SUBJECT: Responds to NRC 930507 ltr containing findings in EDSFI Repts 50-269/93-02, 50-270/93-02 & 50-287/93-02. Corrective actions: detailed single failure analysis of Keowee governor sys will be performed & procedures will be upgraded.

Subject: Oconee Nuclear Site  
Docket Nos. 50-269, -270, -287  
Inspection Report 50-269, -270, -287/93-02  
Reply to Findings

Oconee EDSFI

Title/Subject: Keowee Generator Terminal Voltage

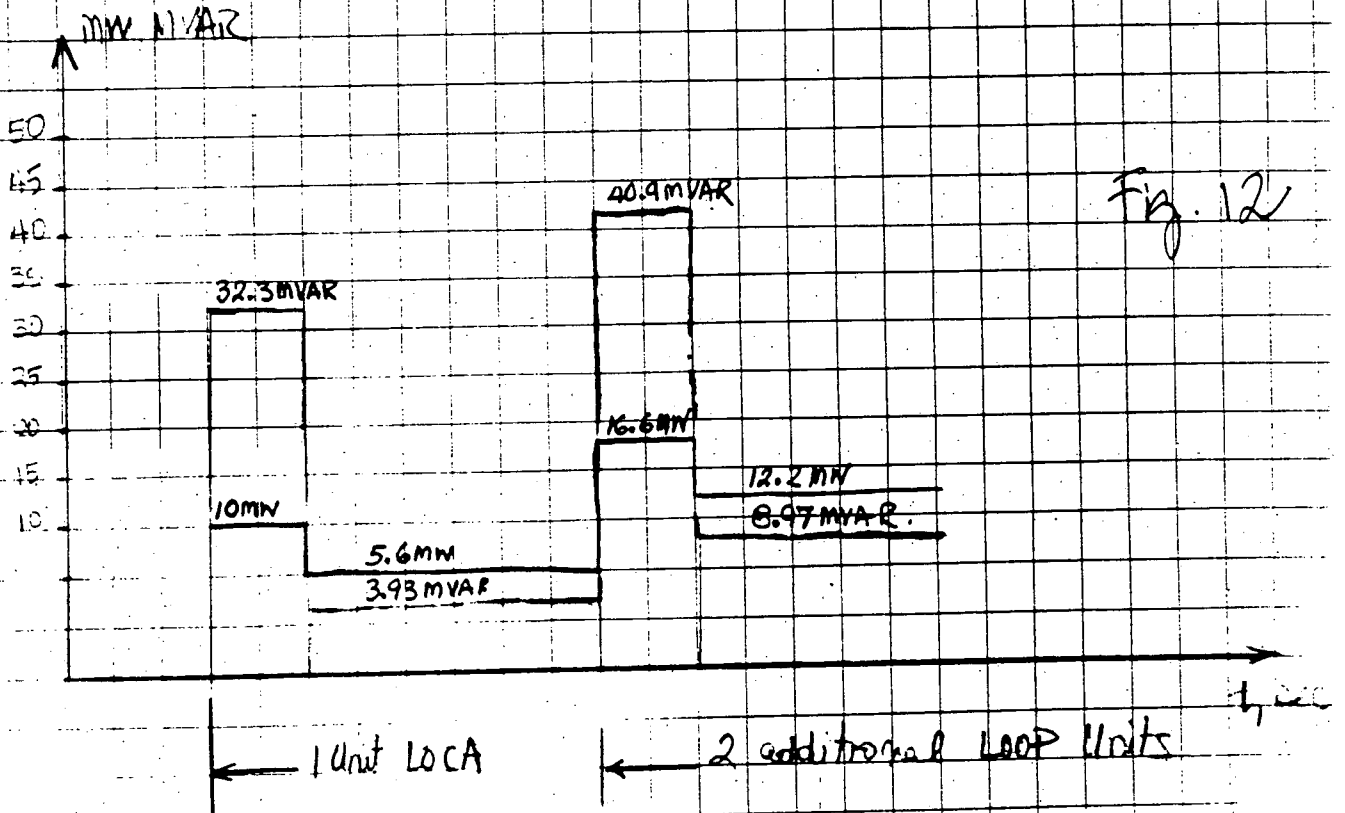
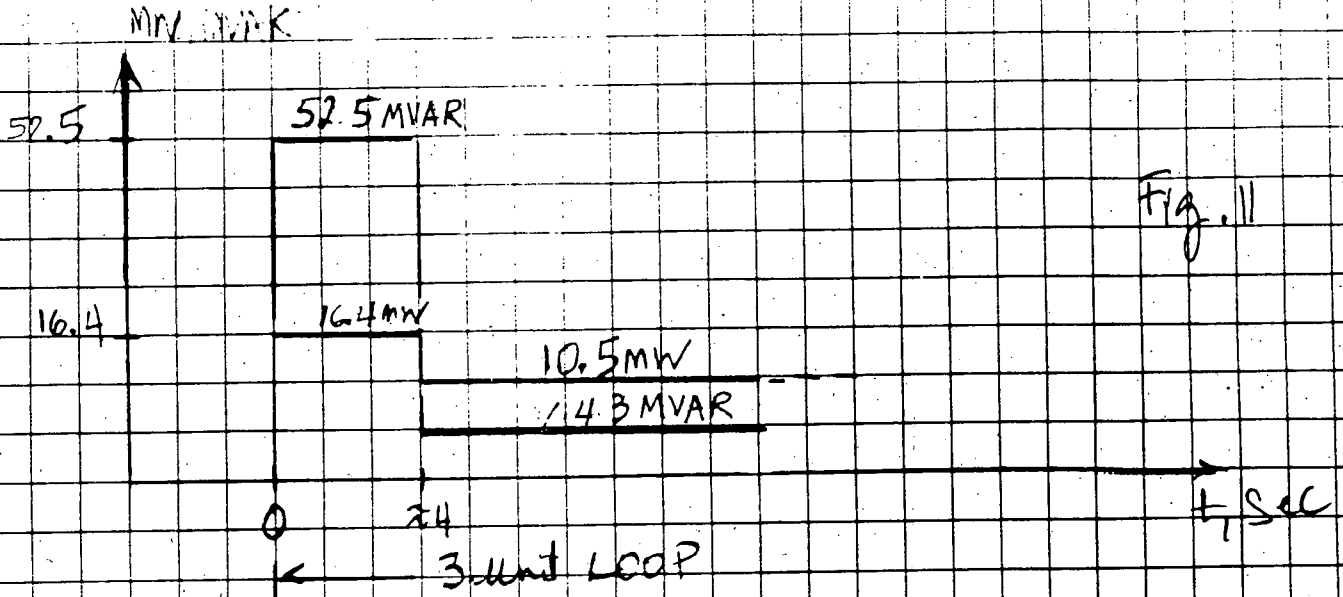
For the LOCA/LOOP condition, when the two loop units are connected to Keowee, the frequency drops to 56.5 Hz and remains below 57 Hz for approximately 10 seconds (see Fig 6). This will result some reduction in process flow. The critical process is the LPI system. B&W analysis requires that 90% of the required flow must be obtained within 48 seconds. This 90% represents 90% flow of one LPI pump. In a LOCA event, two LPI pump motors will be started and run. It is judged that the system frequency of 56.5Hz for 10 seconds will not cause two LPI pumps to produce flow less than the analyzed flow rate. Since this low frequency condition occurs during the time that two other LOOP units are being loaded to Keowee( due to a single failure of the overhead path), other failures need not be postulated and therefore the two LPI pumps should always be available.
